## REVISED RESPONSE TO REQUEST FOR ADDITIONAL INFORMATION

### APR1400 Design Certification

RAI No.: 175-8034  
SRP Section: 05.04.12 – Reactor Coolant System High Point Vents  
Application Section: 5.4.12  
Date of RAI Issue: 08/20/2015

### **Question No. 05.04.12-4**

Figure 5.4.12-1 Reactor Coolant Gas Vent System Flow Diagram

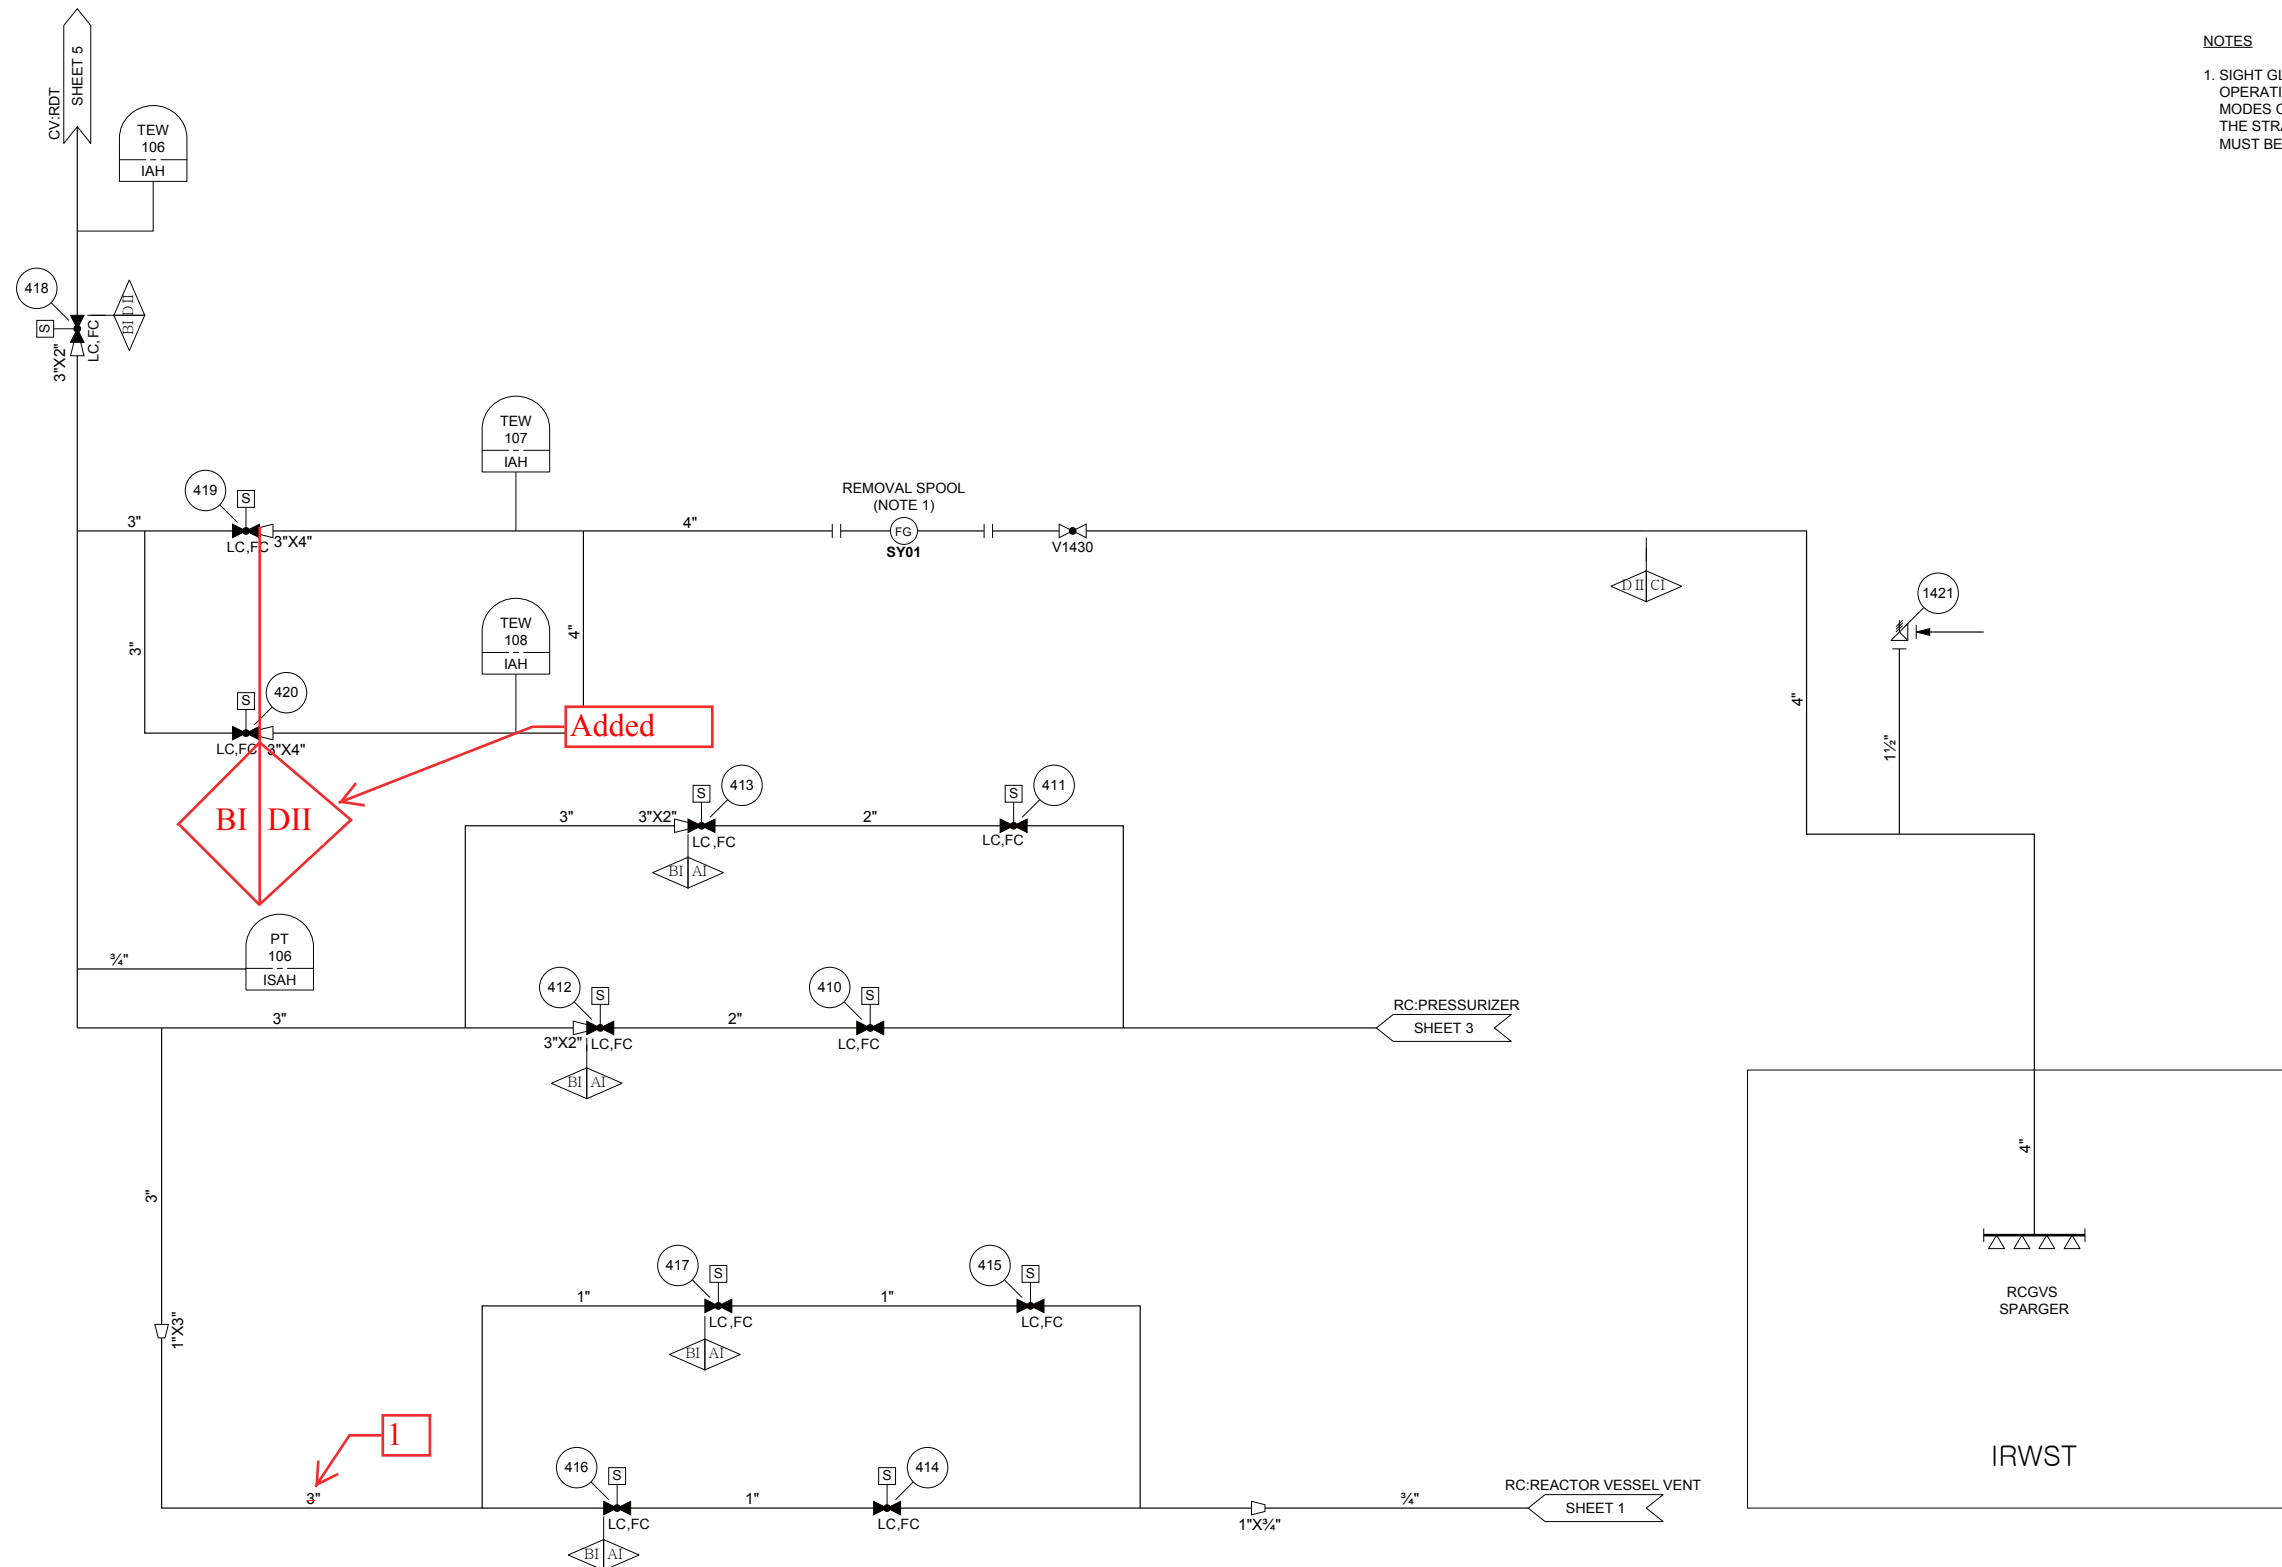
- b. Staff identified an omission in DCD Tier 2, Figure 5.4.12-1, as well as a typographical error:
  - (1) Markings that should indicate a transition from Seismic Category I and Quality Group B to Seismic Category II and Quality Group D after isolation valves V419 and V420 are missing.

- (2) The size of the line downstream of isolation valves V416 and V417 in the RCVH portion of the RCGVS appears to jump from 1" to 3" without passing through a flow enlarger.

The downstream line size of isolation valves V416 and V417 will be changed from 3 inches to 1 inch, and Qualify Group and Seismic Category will be added after V419 and V420 in DCD Tier 2, Figure 5.4.12-1 as shown in Attachment 2.
